MOUNT PLEASANT OPTIMISATION PROJECT

Submissions Report

On 19 March 2021, the Department of Planning, Industry and Environment requested that MACH prepare and submit a Submissions Report for the Project (this report). Accordingly, this report provides MACH's responses to issues raised in submissions.

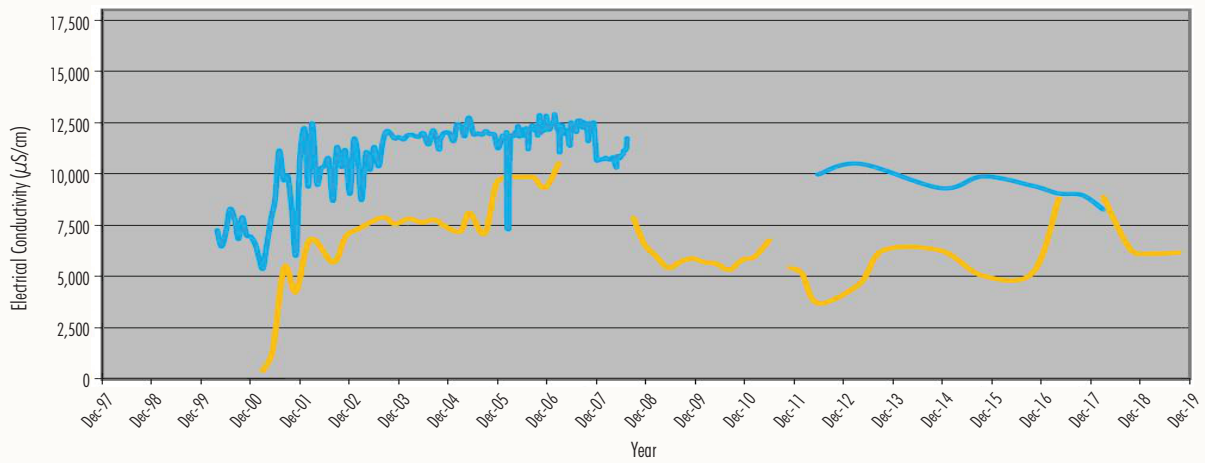
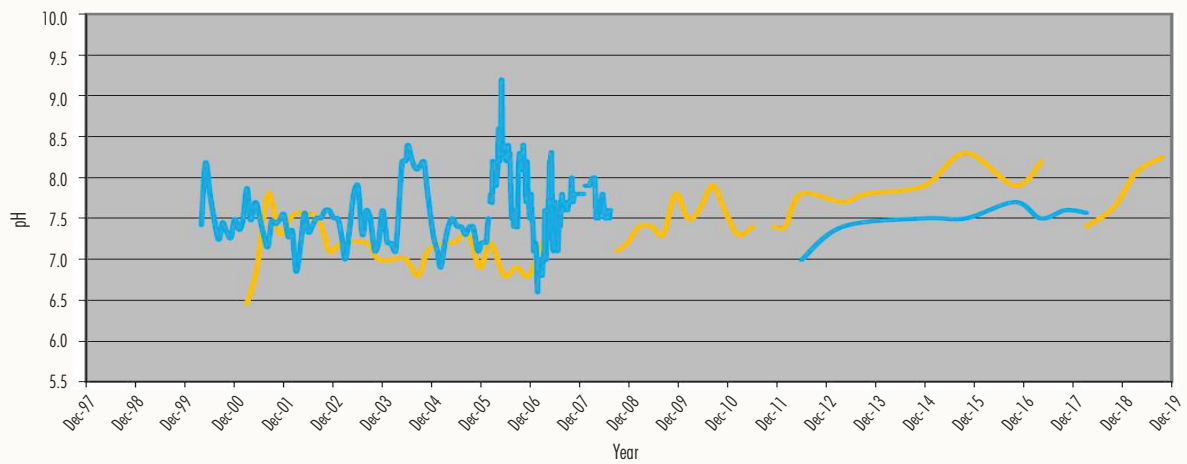
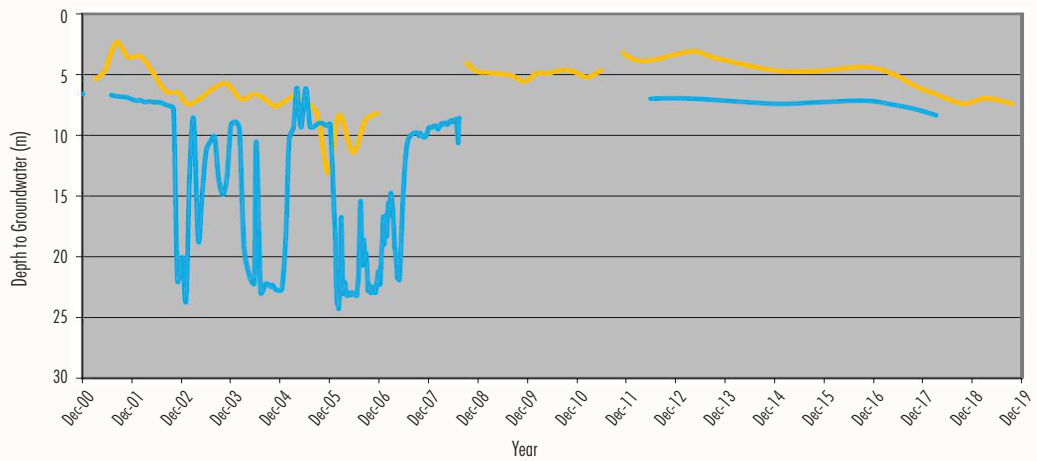
The Belgrave bore in the north-west of ML 1645 (Figure 7-18 of the EIS) is the only location that is active and not dry, and predicted to experience more than 2 m drawdown due to Mount Pleasant Operation (Appendix C of the EIS).

The Belgrave bore has been monitored by Dartbrook Mine since 2000. Monitoring data collected from the Belgrave bore is reported in the *Dartbrook Mine – Annual Review 2019* (AQC Dartbrook Management, 2020). In summary (Figure 5):

- the Belgrave bore recorded a decline in groundwater levels in response to mining between 2004 and 2006;
- pH has fluctuated between 6.6 and 9.2; and
- EC has ranged from approximately 5,000 $\mu\text{S}/\text{cm}$ to 12,500 $\mu\text{S}/\text{cm}$.

Consistent with the requirements of the AIP, MACH would continue to implement appropriate contingency measures for Project related drawdown greater than 2 m at any relevant private or public groundwater bores. The contingency measures developed for the existing/approved Mount Pleasant Operation include:

- deepening the affected groundwater supply bore;
- construction of a new groundwater supply bore; or
- provision of an alternative water supply.

Figure 3.4 Water Sharing Plan areas and AIP setback distances

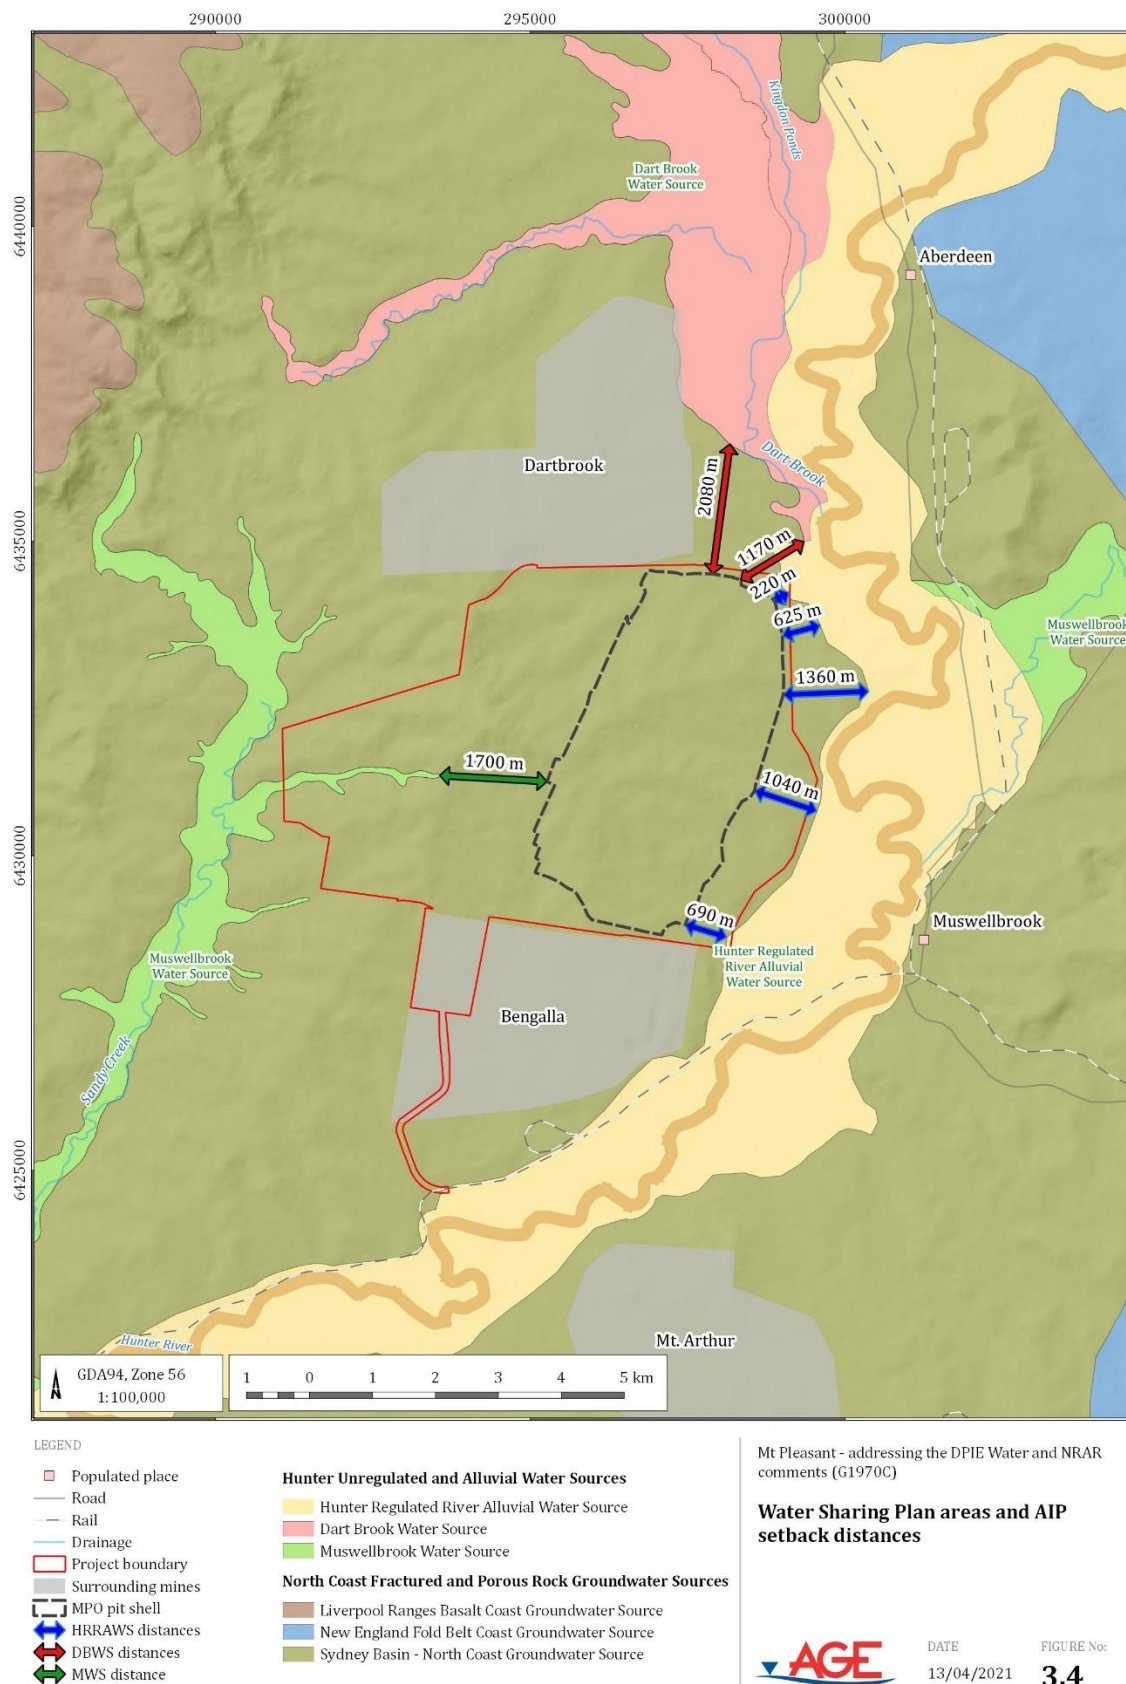
DPIE – Water and NRAR have requested that setback distances from the mine to recognised alluvial water sharing plan (WSP) boundaries be confirmed. Measurements to the relevant boundaries were made in Geographic Information System (GIS) software QGIS as pictured in Figure 3.4.
